REGIONAL REVIEW NOTIFICATION

Name of Proposal: Lakeview at Stonecrest

Review Type: Development of Regional Impact

Preliminary Report:	March 13, 2006	DEVELOPMENT OF REGIONAL IMPACT REVIEW REPORT	Project:	Lakeview at Stonecrest #987
Final Report Due:	April 12, 2006		Comments Due By:	March 27, 2006

BASEMENT/10 UNITS SLAB/12 UNITS
Concept Plan
Lakeview at Stonecrest
Landlot: 181 District: 16th Section: - County: DeKalb State: Georgia
STONECREST ATLANTA, LLC

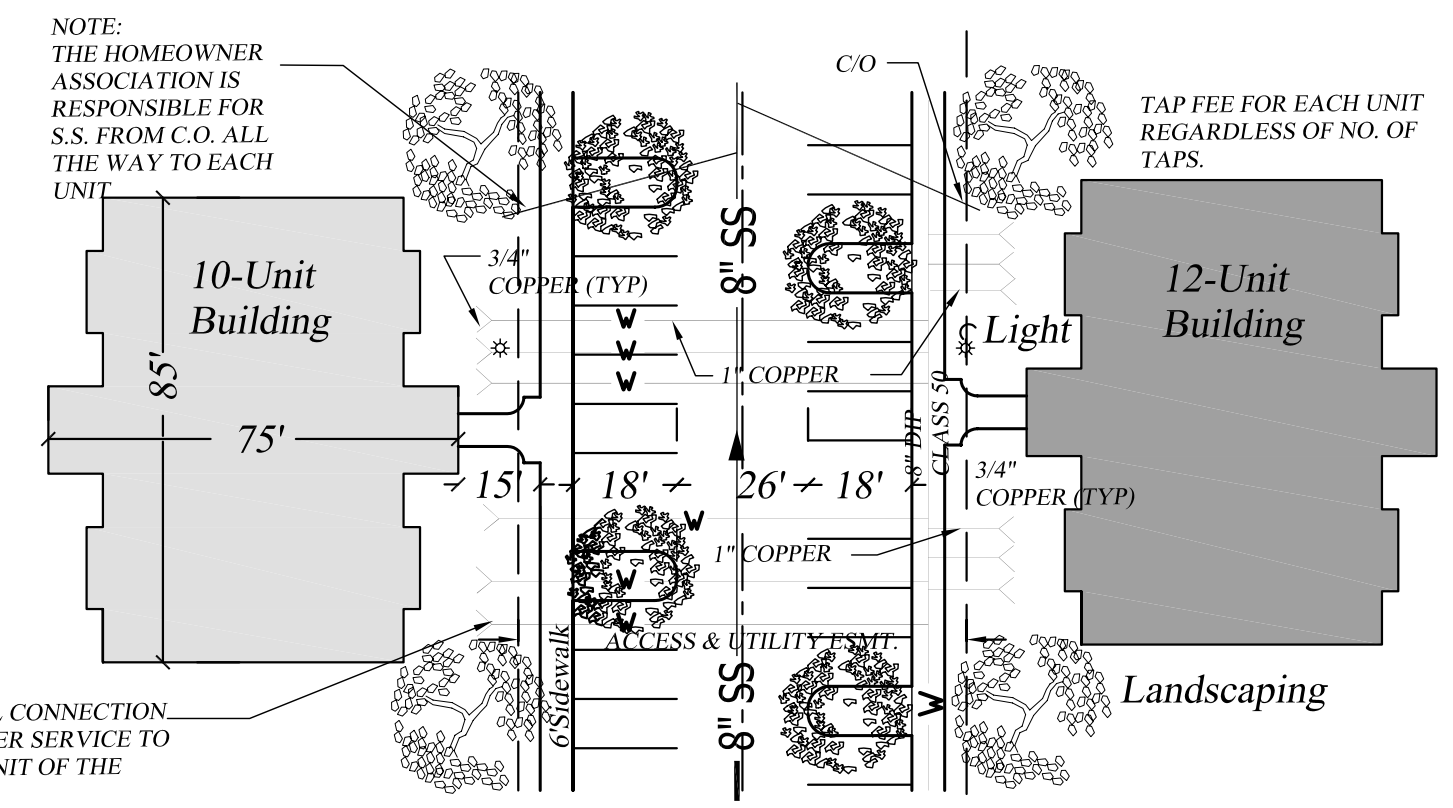
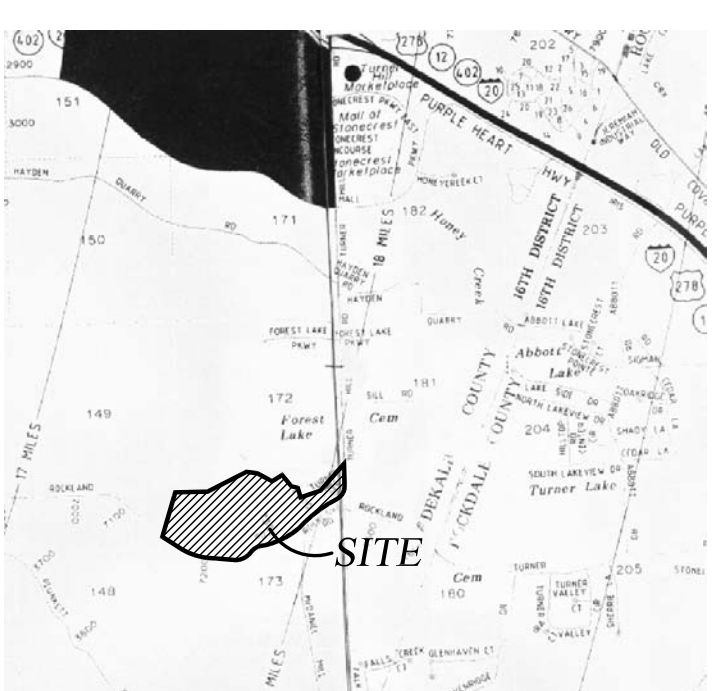
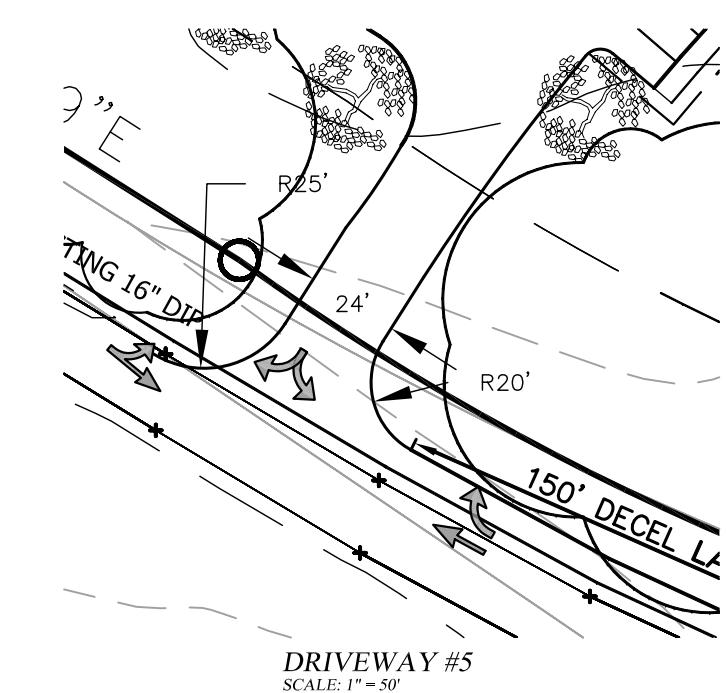
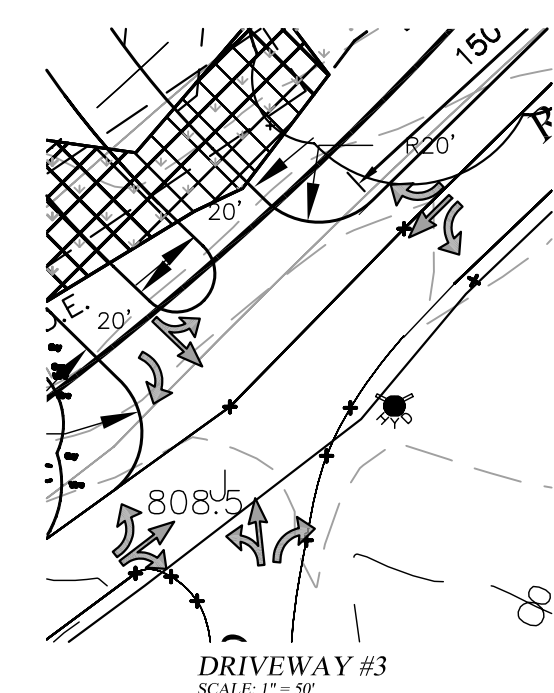
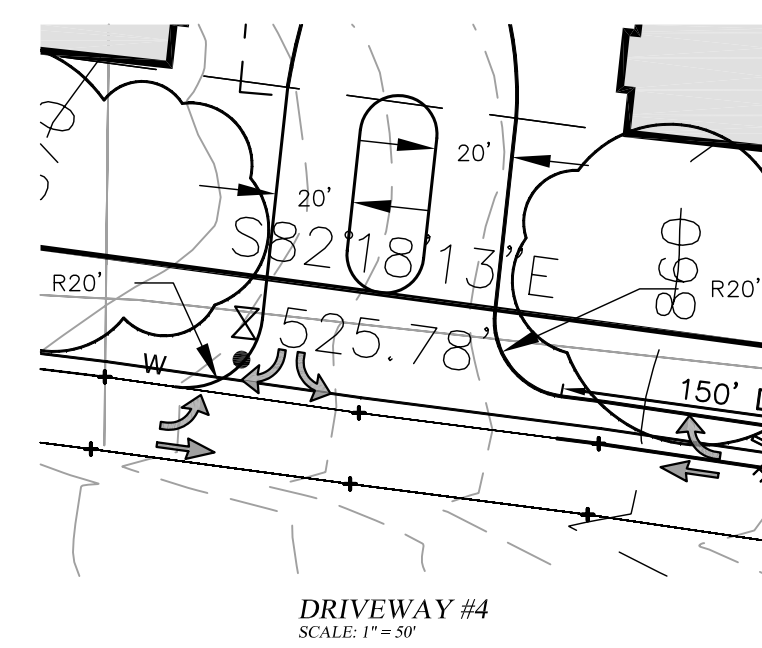
ARC staff requested a statement concerning the wetlands impact from the developer. The statement should include whether a Core permit is needed at this time.

Lakeview is located just south of another DRI called Forest Lake. It is recommended that the proposed development provide appropriate pedestrian connections to the Forest Lake development. It is also recommended that the proposed development provide adequate pedestrian connections to the commercial area within the Lakeview development.
